Further Statement

This Further Statement covers Proposed **Lot 50**

Disclosure Plan for Proposed Lot 50 (Restricted) on SP330363

Level Datum: AHD der.
 Origin of Levels: PSM 49894
 RL of Origin: 62.350
 Contour Interval: 0.25m
 Scale @A3 1: 200
 Dwg No. 9780 S 17 DP B_50

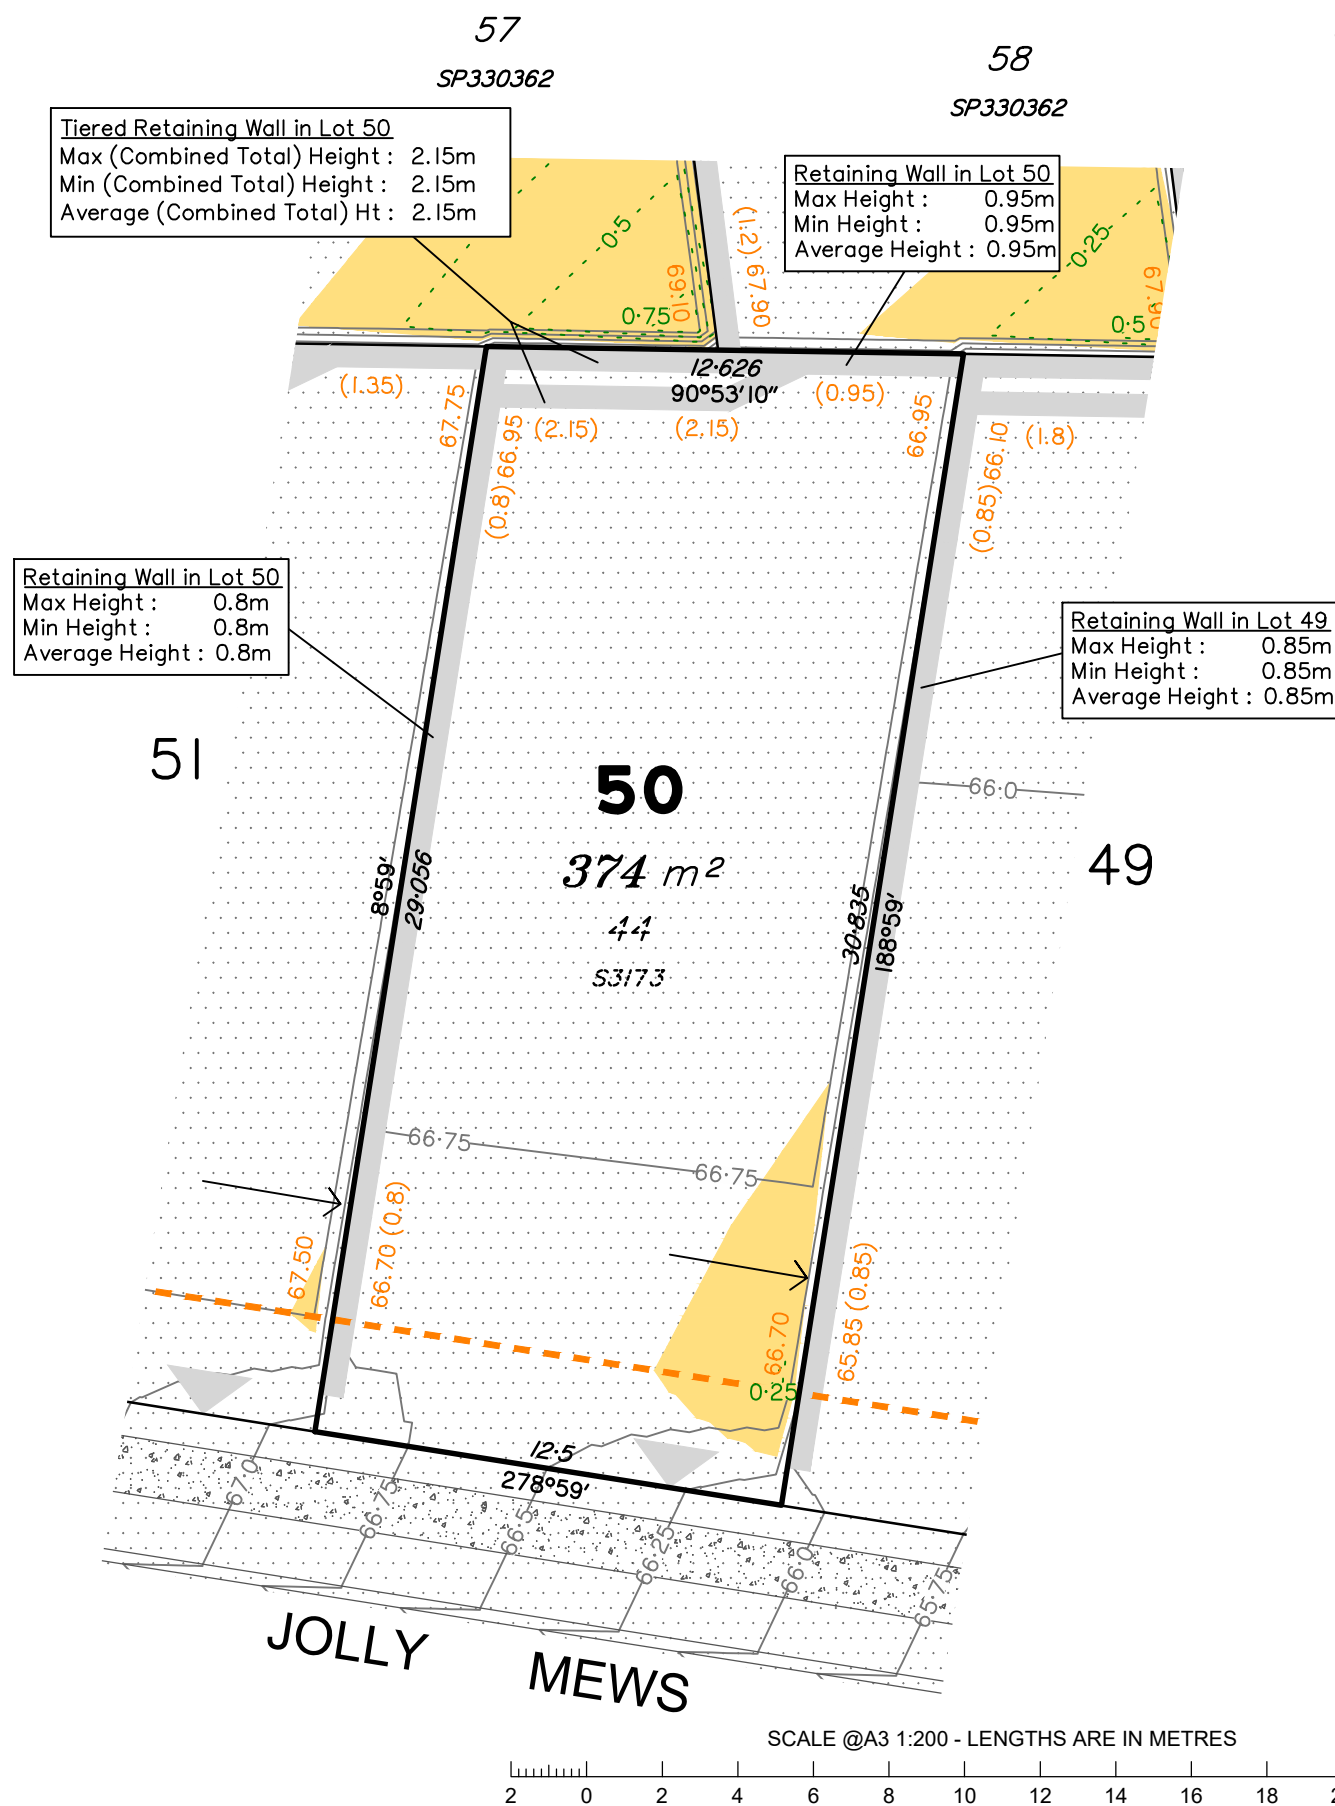
The retaining wall in the north-west corner of the lot has been changed to a two-tier retaining wall.
